Historic Architectural Review Commission Staff Report for Item 13

Application Number: H2023-0037

Address: Lazy Way Lane / Shrimptoat Sound Studio

Description of Work:

Figure 2a. Existing Structure Floor Plan

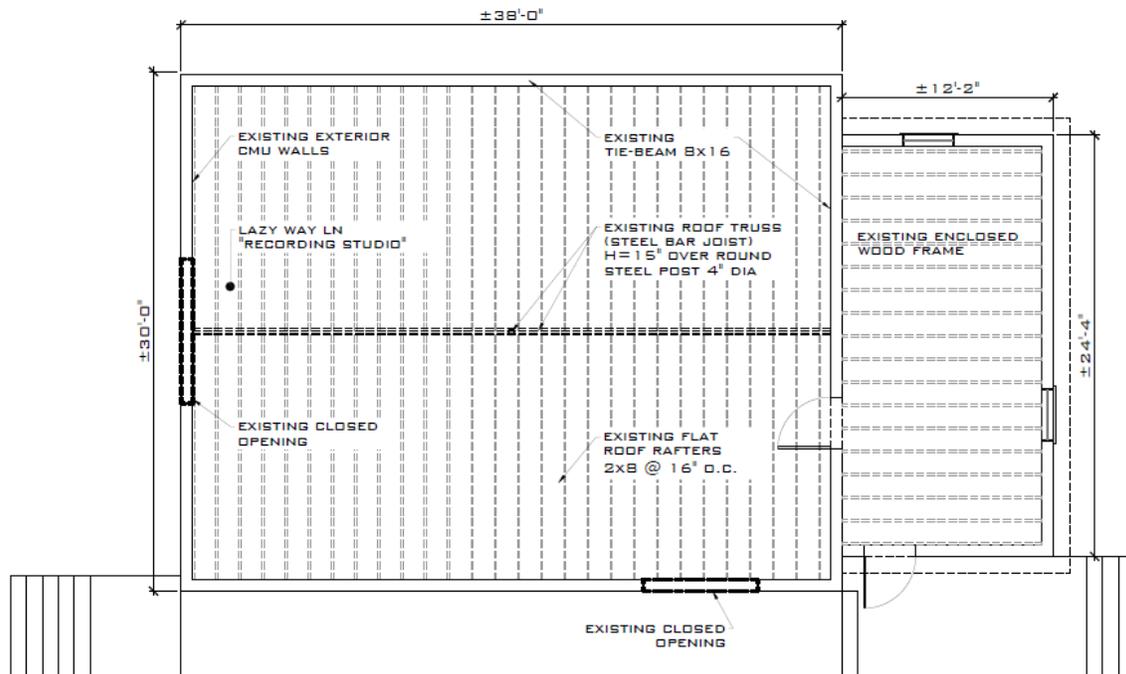
The wood frame shed is approximately 24.5ft by 12ft. Side addition height is approximately 7-8 ft. Roof pitch is $\pm 1:12$. Roof rafters are inaccessible 2x members covered with interior finishes. There are noticeable signs of foundation and framing failure, the addition is separating from the main structure.

In my professional opinion the majority of wood floor system and foundations of the side addition require replacement, which includes new concrete piers, new sill beam and new floor joists to be sistered with new members supported by new ledger. It would be advisable to replace the floor deck entirely at the same time – but this will require a complete replacement of the floor finishes and removal of all items from the space interior.

Figure 2b. Existing Structure Roof Plan

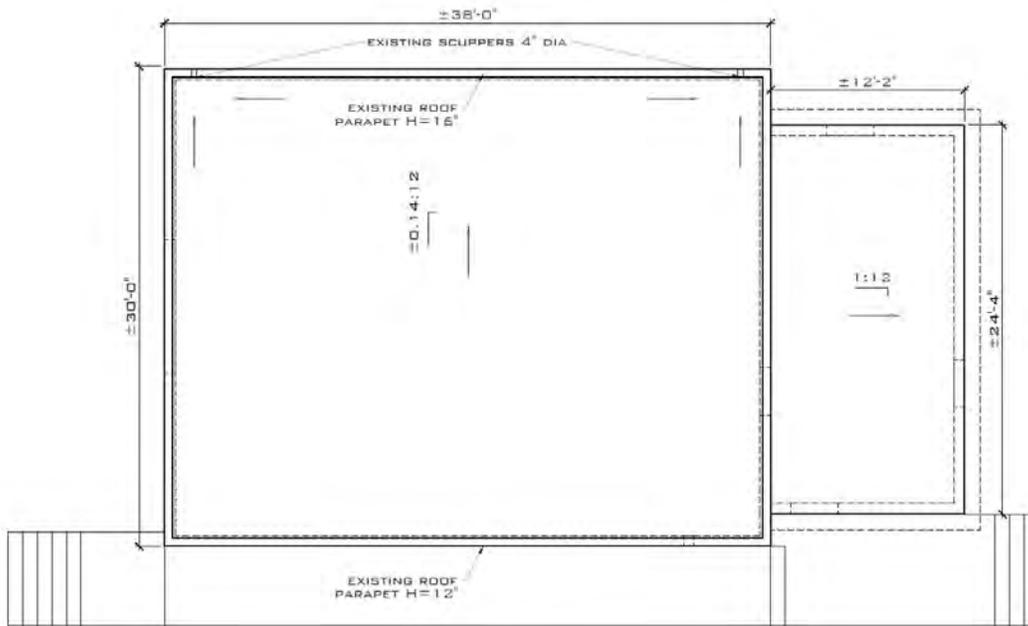
Existing commercial building is approximately 30ft wide by 38ft long CMU (concrete masonry unit) structure with unreinforced blockwork topped by cast-in-place tie-beam and short parapet wall. Building height is ±12ft to the top of parapet wall. Roof system consists of steel truss running along the middle of the building and supported by 4" dia. round steel column and exterior walls on the ends. Low pitch roof rafters 2x8 wood members @ 16" o.c. are supported by the central beam and have ends embedded

into concrete above the tie-beam. There are evident concrete cracks on the tie beam around main building perimeter.

In my professional opinion overall condition of the building is poor. Concrete tie-beam around entire building perimeter needs to be replaced, due to the fact that parapet wall above the tie-beam is short it is very likely that it will not survive the demolition of the supporting tie-beam and blockwork will lose its integrity. New parapet wall cast together with the tie-beam is recommended. Roofing membrane around wall perimeter will require significant repairs with proper parapet wall termination – a complete roofing replacement is recommended.

Currently the roof of the principal structure consists of a 3-ply membrane installed over low pitch roof deck with two scuppers of a small diameter (4"). The size of scuppers is prone to closing by debris and may result in standing water intrusion into interior or even damage to supporting structure. Our recommendation on upsizing to 8"x16" scuppers and installation of downspouts to direct water away from the walls. The steel trusses, posts and visible roof framing elements are in satisfactory condition.
